Changes to Bid Information

CLIENT: DEKALB COUNTY DEPARTMENT OF WATERSHED MANAGEMENT
DEKALB COUNTY, GEORGIA

PROJECT: CHAMBLEE DUNWOODY ROAD WATER MAIN REPLACEMENT PHASE II

IF YOU DIG GEORGIA...
CALL US FIRST!
UTILITIES PROTECTION CENTER
1-800-282-7411
(404) 325-5000
(metro Atlanta only)
IT'S THE LAW

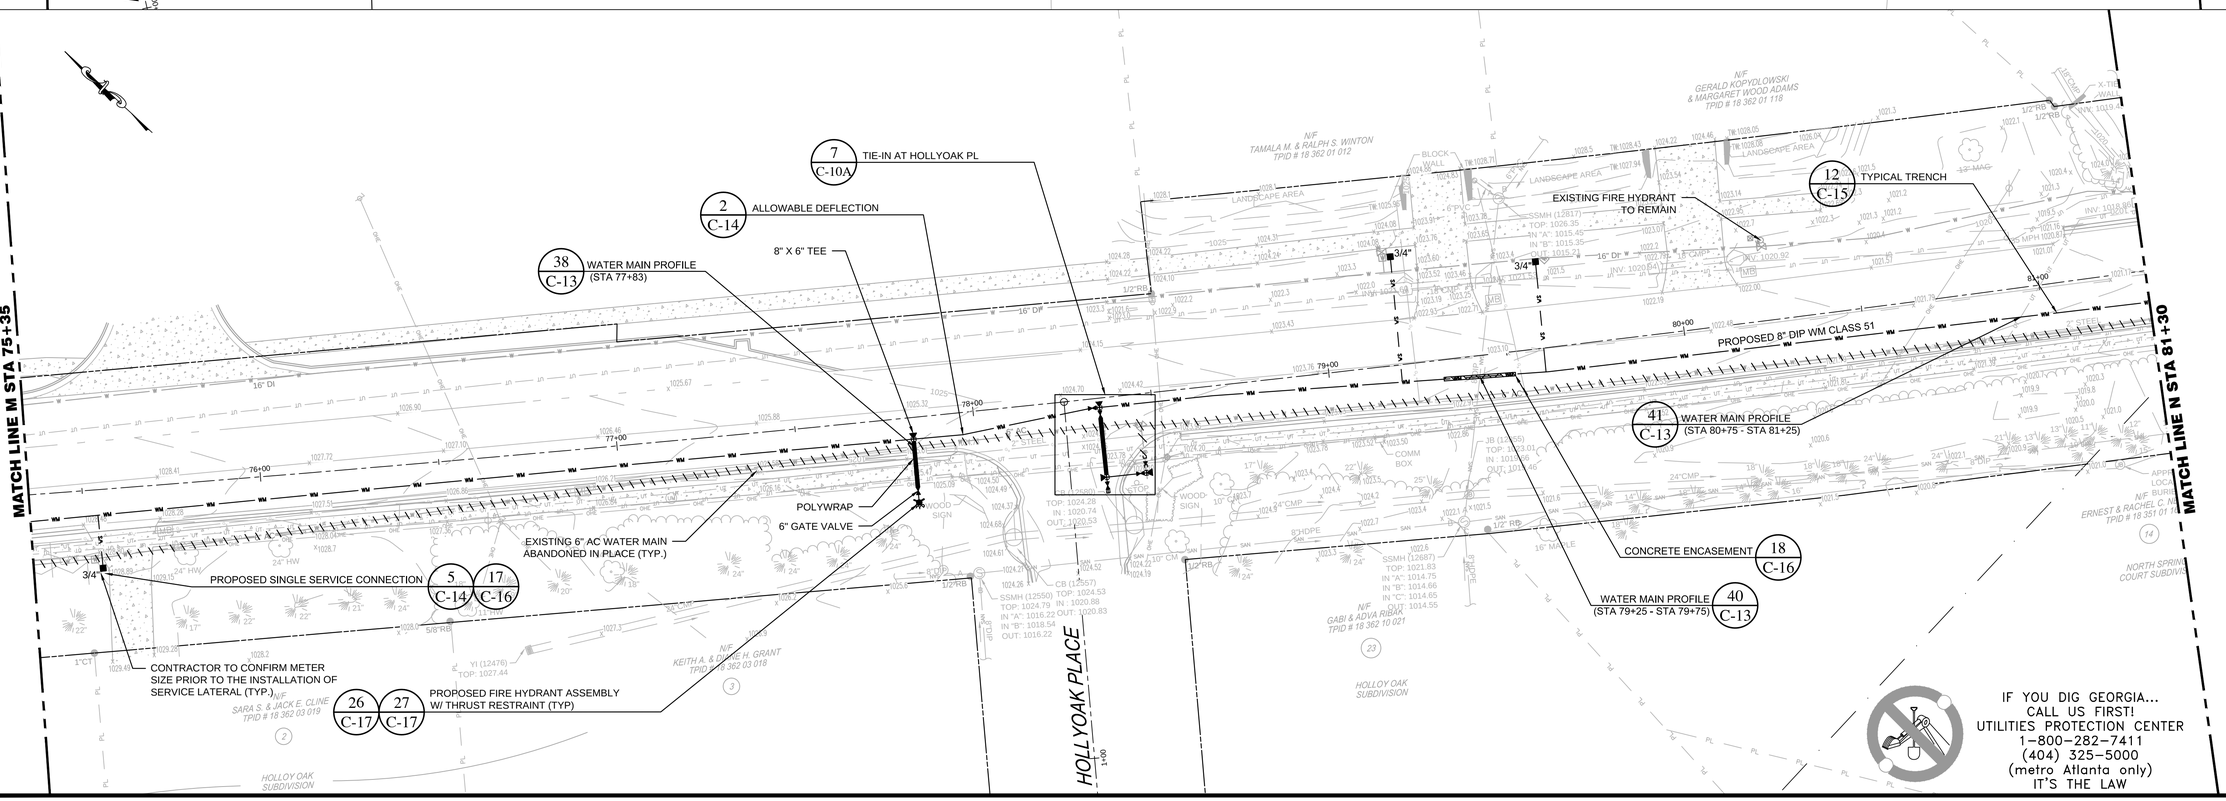
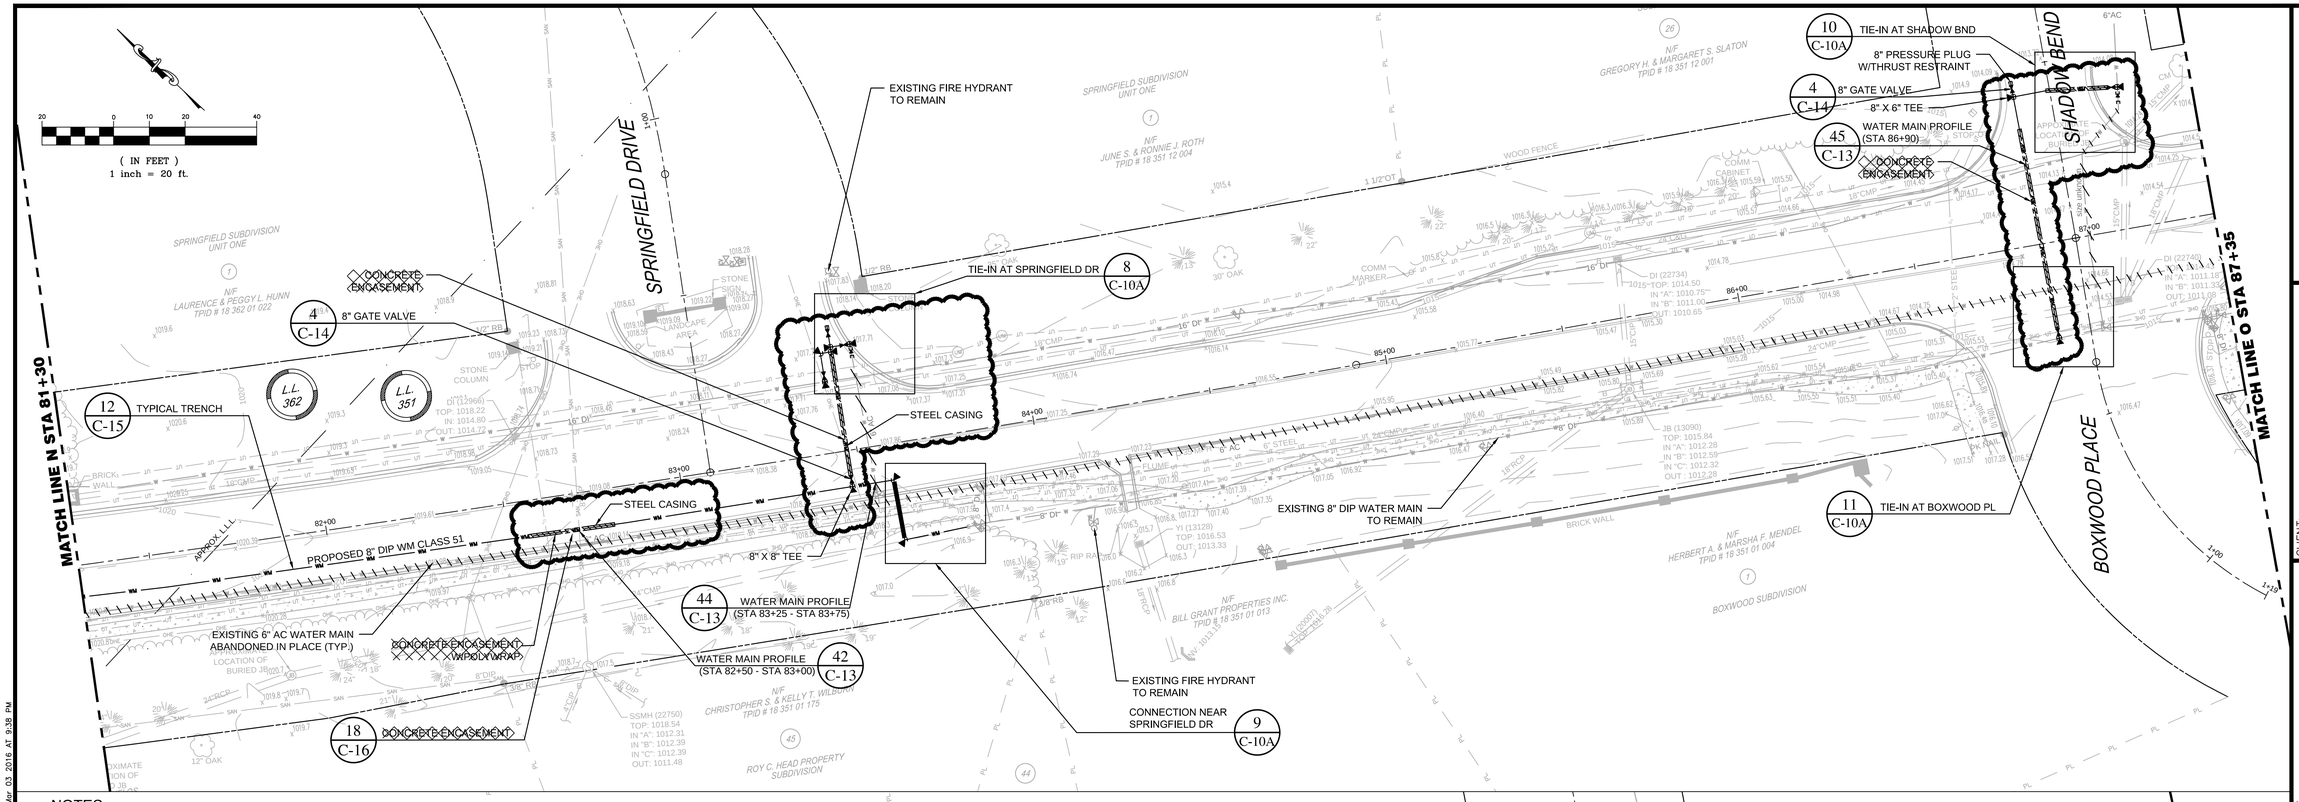
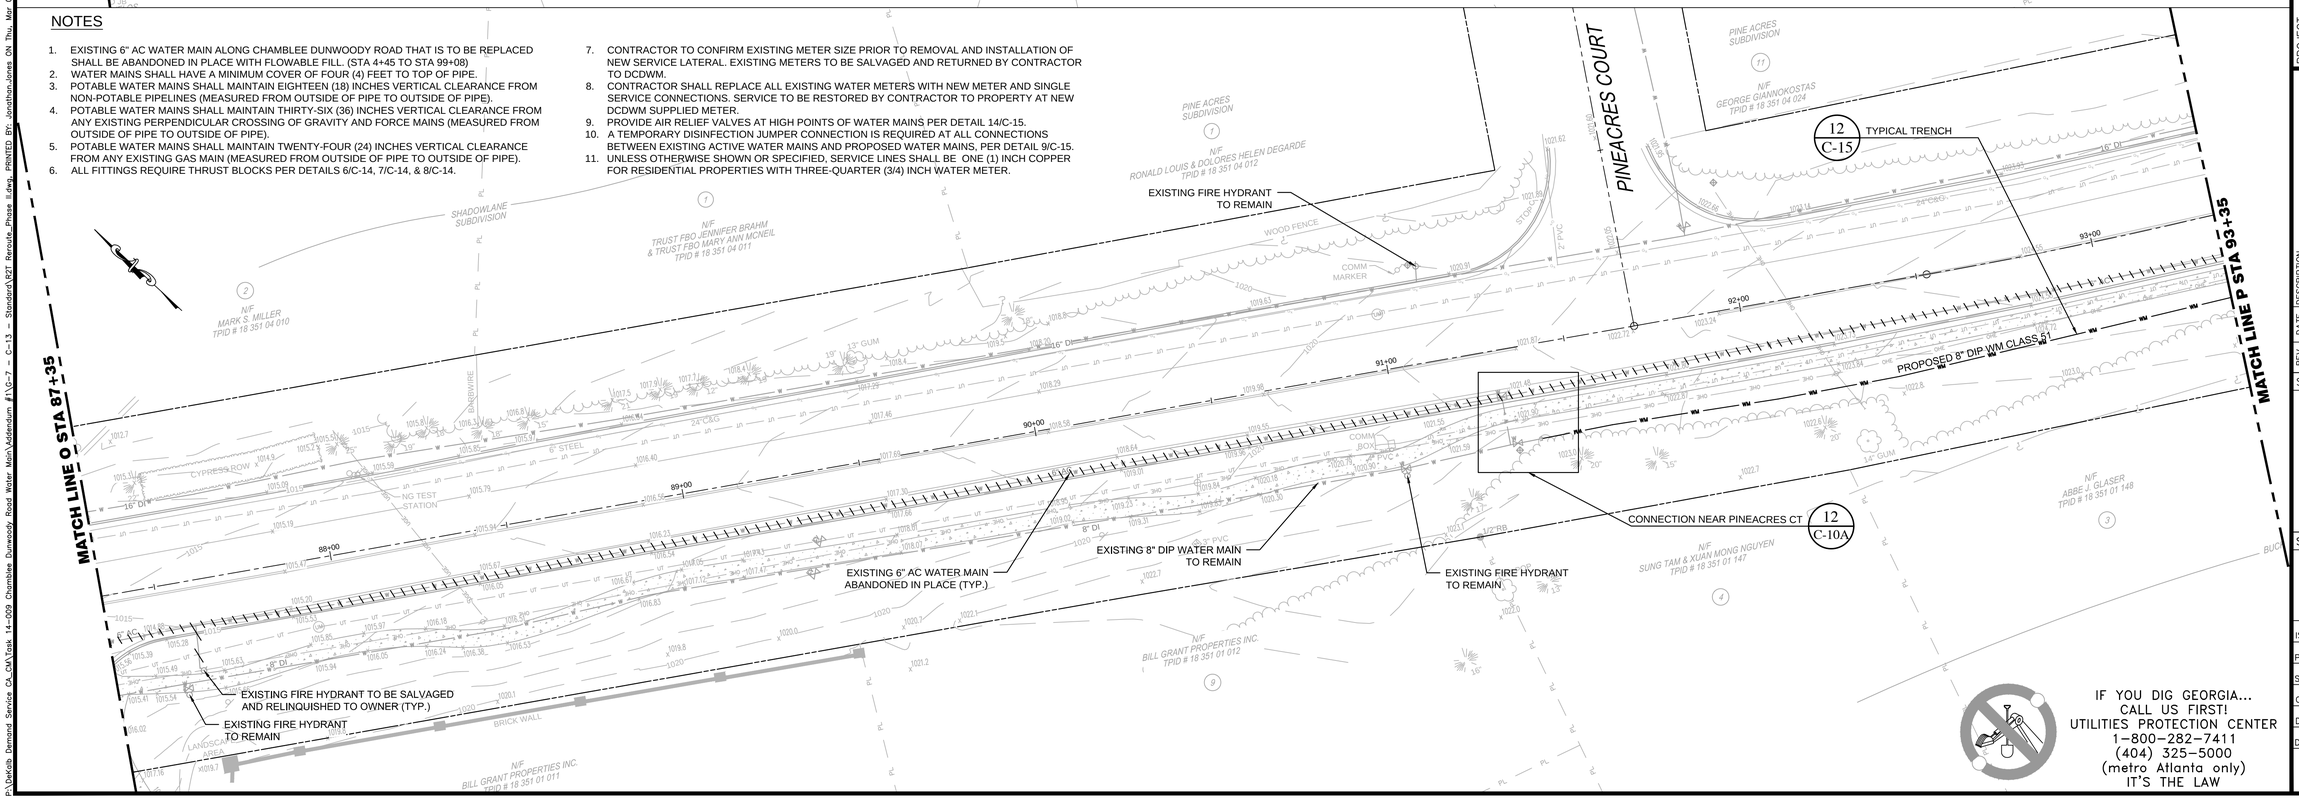
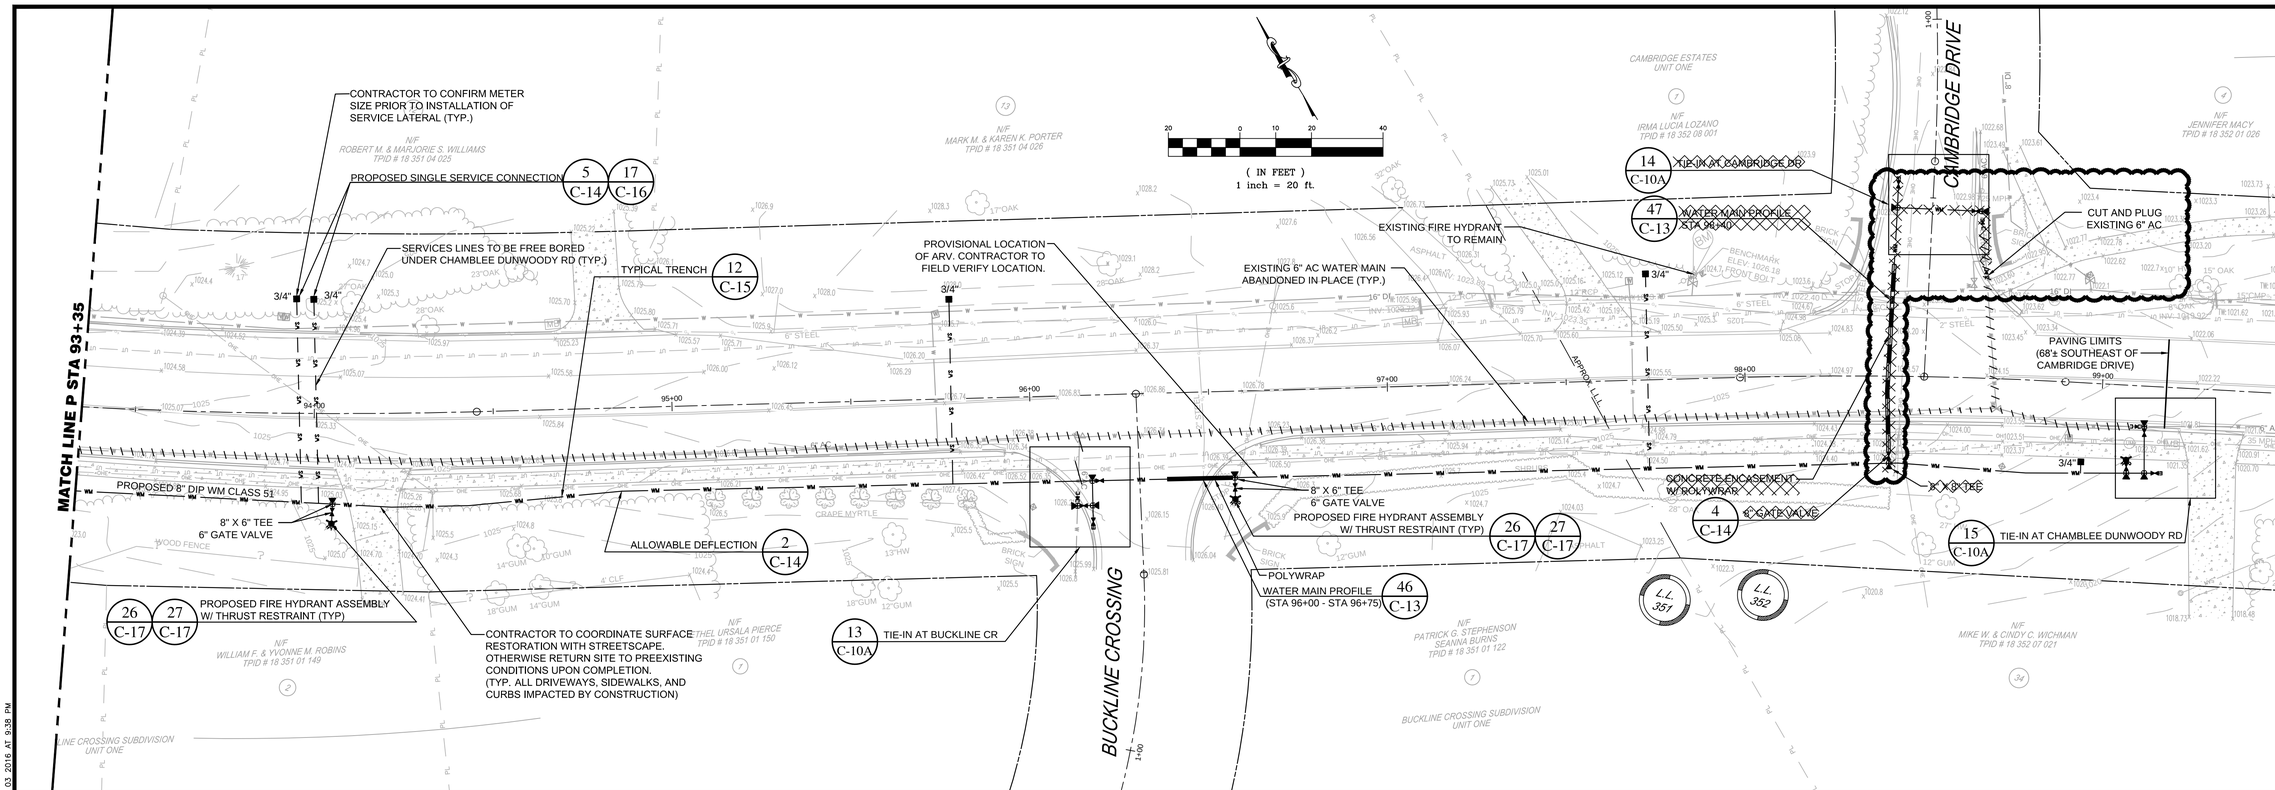
The changes are generally of two types: 1. 16"x8" Tapping Sleeves and Valves were added at several locations along the alignment. 2. Concrete encasement was generally removed and replaced with either no special handling or a jack and bored steel casing to avoid impacts to existing or proposed infrastructure. In some cases, it was determined that concrete encasement should not be altered.

The bid items indicate that there will be 270 LF of Jack and Bore operation to be performed. However the plans do not indicate ANY jack bore operation to be performed anywhere. It is imperative to know WHERE you intend to jack and bore as the location can drastically change the price. For instance if I have to Jack and Bore FROM the middle of Chamblee Dunwoody TO the middle of Chamblee Dunwoody, then the expense of traffic control, excavation and site restoration in the middle of a busy street will be way different than if I have to Jack and Bore across a side street with both of my pits off the road in the dirt.

3. The plan does not specify the location of jack and bore. What is the location?

Response: The drawings have been updated to reflect the locations of the jack and bore for the 8-in DIP WM and water service lines. These locations are indicated on the plan view, the Insets (where appropriate), and the profile views.

For the WM, in addition to the 8-inDIP pipe, the pay items applicable for each case of Jack and Bore are:
615-1000 Jack and Bore Pipe, 8”DIP, and
670-7000 Steel Casing, 18-Inch.

For service lines, in addition to the copper tubing, the pay item applicable to each case of Jack and Bore is:
615-1002 Jack and Bore Pipe, Copper ¾”, 1”, or 2”.

Service connections will direct bore and not be contained in a carrier pipe. All long-side services shall be jack and bored.
